DELEGATED PLANNING APPLICATION REPORT

Application number:	TP-2017-616
Applicant:	MG Leicester Pty Ltd
Address:	4-12 Leicester Place, CARLTON VIC 3053
Proposal:	Demolition of existing building and the construction of a mixed use building, comprising of residential hotel and retail premises (other than Adult sex bookshop, Hotel, and Tavern).
Date of application:	27 July 2017
Responsible officer:	Kate Yuncken

North and west elevations of TP-2015-983

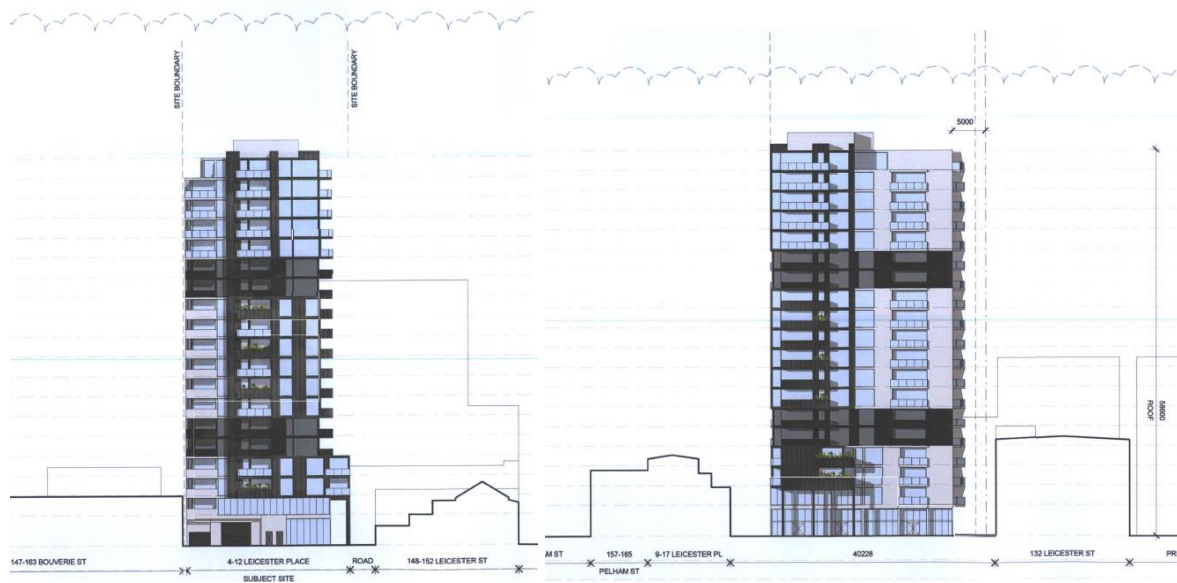
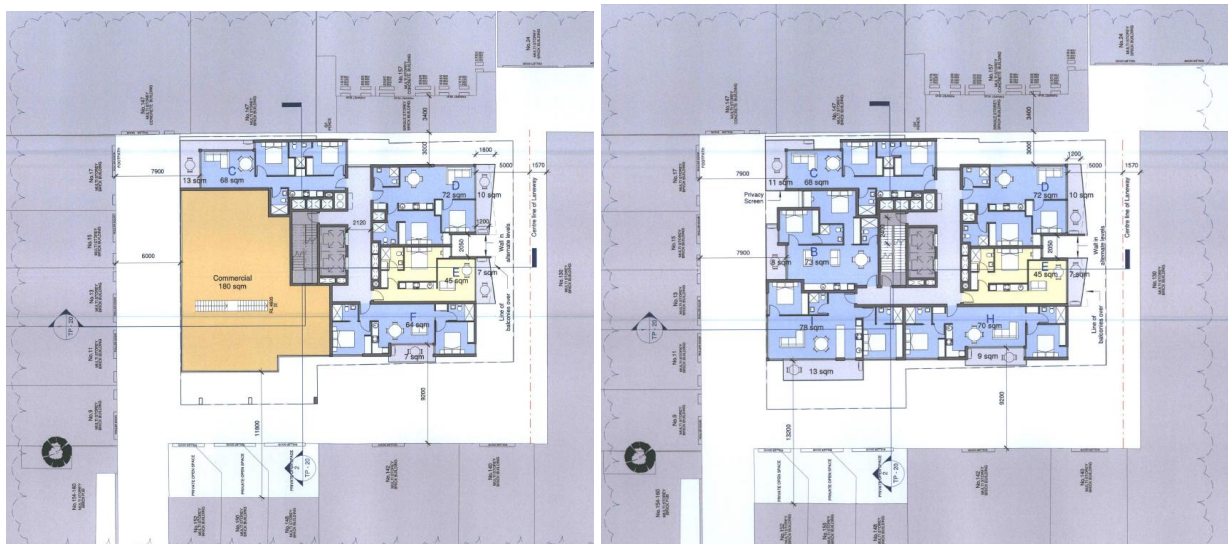
- 31 For these reasons we find that the proposed development tries to achieve too much built form, in contrast to the strategic intent of DDO61 for the City North Area. The height of the proposed development significantly exceeds the preferred maximum height encouraged by DDO61, and will significantly and unreasonably challenge both the heights strategically intended for this precinct, and the hierarchy of heights intended for the City North Area, as set out by the Melbourne Planning Scheme. We consider both of these outcomes to be undesirable, and will result in an urban form that DDO61 specifically discourages for the review site. Further, the extensive built form that is proposed for the review site will cause amenity impacts on surrounding residential properties which are greater than those reasonably contemplated by the form of development encouraged by DDO61 and the broader guidance provided by the Melbourne Planning Scheme. The built form also contains setbacks that will not achieve the equitable development of this and an adjoining property.

Original plans 27 July 2017 west elevation and revised plans 18 June 2018 west elevation

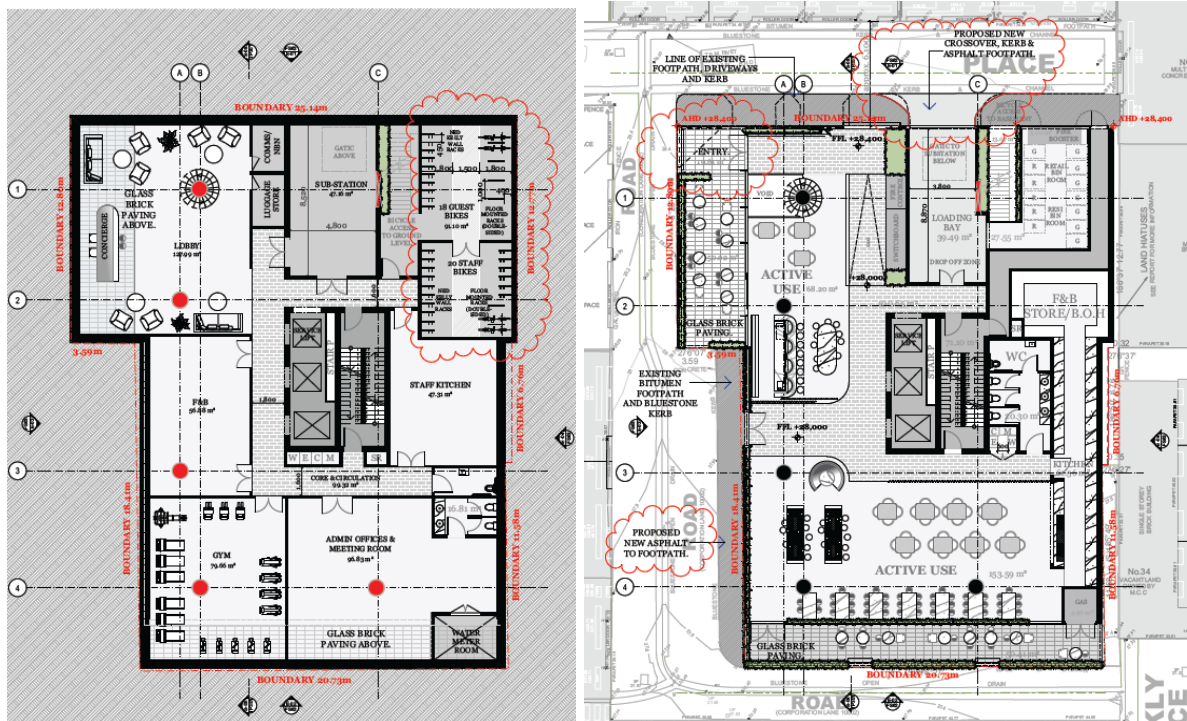
On 24 August 2017 the City of Melbourne's formally requested for further information from the applicant. In the request letter significant concerns with the proposal were also raised stating that:

Please note that Council officers have very significant concerns with the scale and architectural merit of this proposal. It is highly unlikely that the proposal will be supported in its current form. It is recommended that the proposal be significantly amended to meet the requirements of DDO61 Area4.1. If you wish a meeting can be held with yourself and Council officers. Please contact me to arrange a time.

The building height has been reduced from 15 storeys (52.2m) to 12 storeys (40.96m) not including architectural features. Setbacks to the east and west have been increased from the previous scheme, resulting in a narrower tower form. Given the amended height and setbacks, the massing of the tower now adopts a scale, mass and separation from surrounding the buildings that better responds to context and secures amenity.

The proposal still seeks approval for demolition of existing building and the construction of a residential hotel. The building will primary comprise of a residential hotel use (with ancillary roof top terrace), and a retail tenancy at the ground level.

- Construction of a 13 storey (40.96m plus roof terrace and plantroom) building residential hotel for 175 lodging rooms and 324 m² retail
- The development will have a total gross floor area of 8,734 m².

Basement and ground floor - 14 August 2018

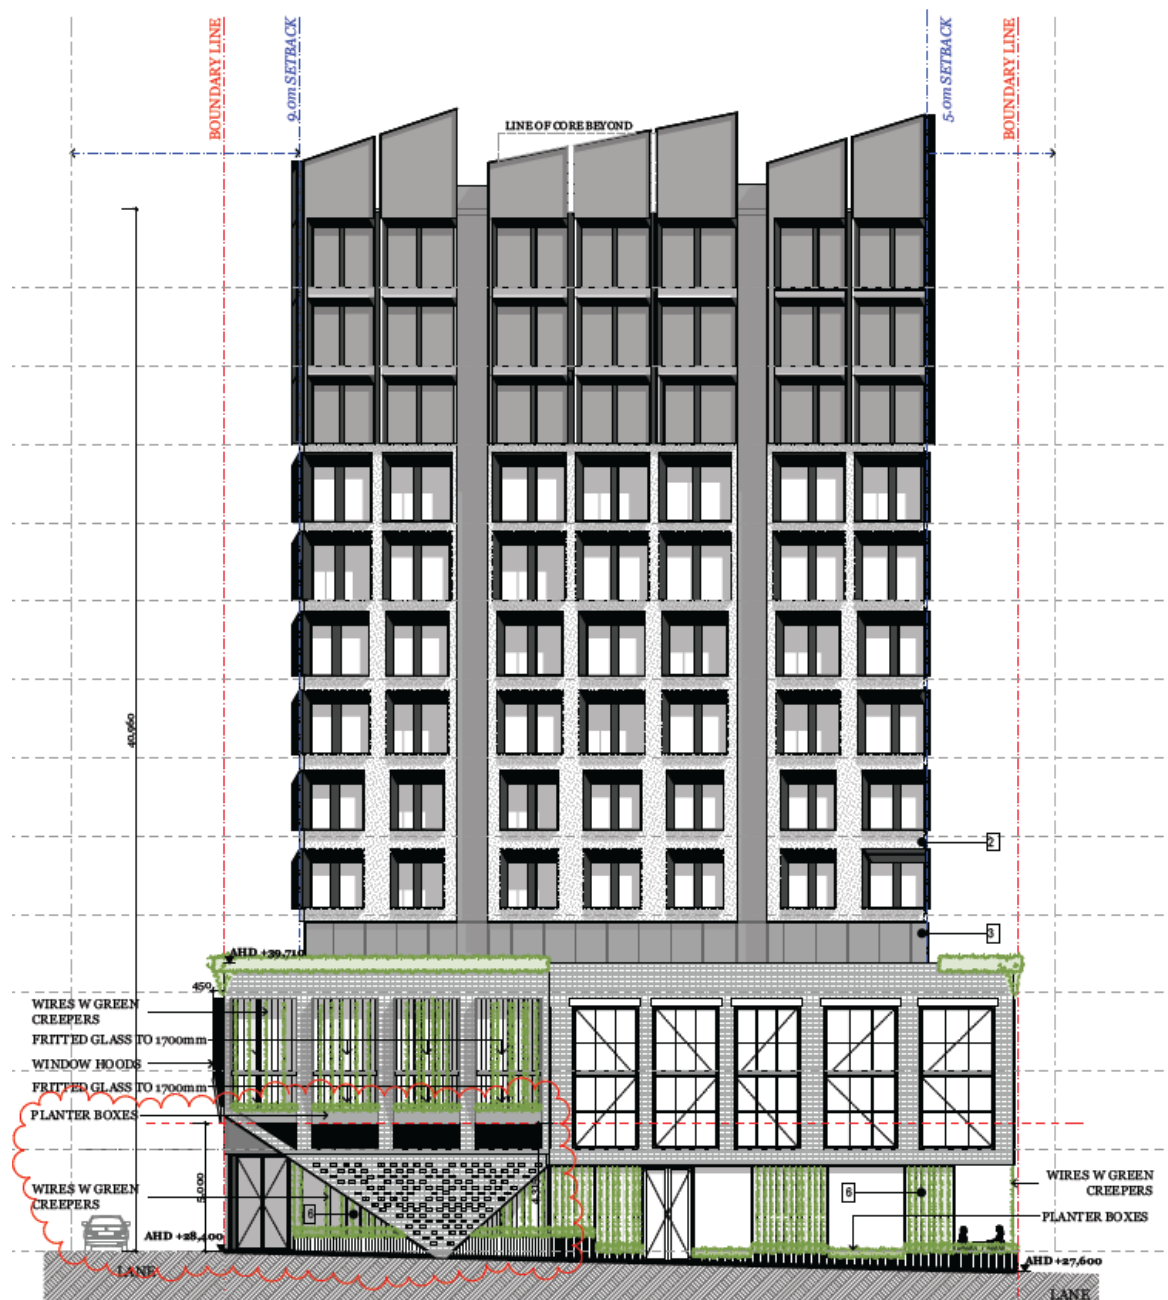
The applicant provided without prejudice plans on 16 August 2018 (plans dated 14 August 2018) to address minor matters raised by Council's Urban Designers and Engineers. The changes included reducing the size of the planter box on the north west corner to allow views into the entry, raising the projecting window hoods and planter boxes to 5m above the footpath and changes to the footpath and kerbs for the loading area.

- Engineering Services objected to the proposed new paving to footpath around the redevelopment. The August 2018 without prejudice plans revised the footpath to address this concern.
- The advice recommends standard civil conditions.

Streetview Google: 9-17 Leicester Place (left), 147-155 Pelham (centre) and subject site (right)

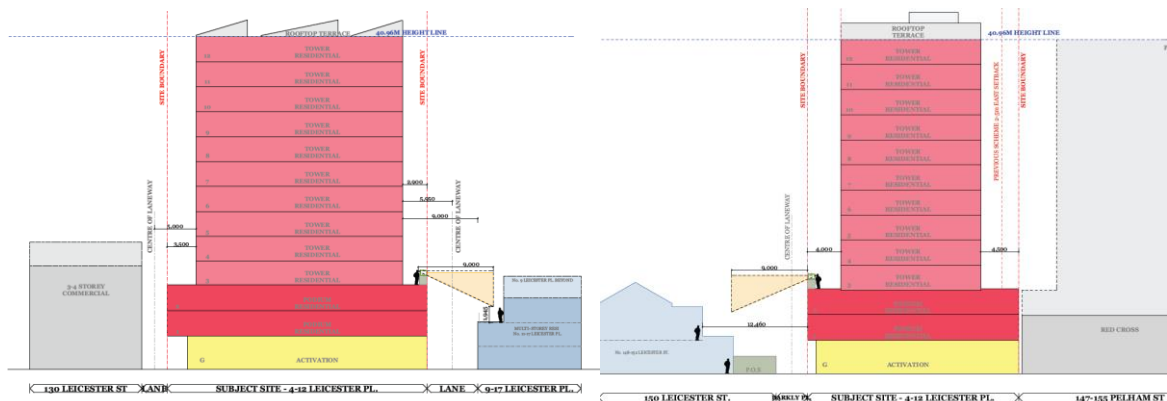
The northern boundary interfaces with Leicester Place and a row of 5, 2-4 storey residential properties with front doors and vehicle access to the lane. These properties have habitable rooms on the second storey and open terraces above with primary outlook to Leicester Place. The proposed podium provides a 6m separation

between these properties across Leicester Place. This is acceptable given the exiting vehicle dominated interface.
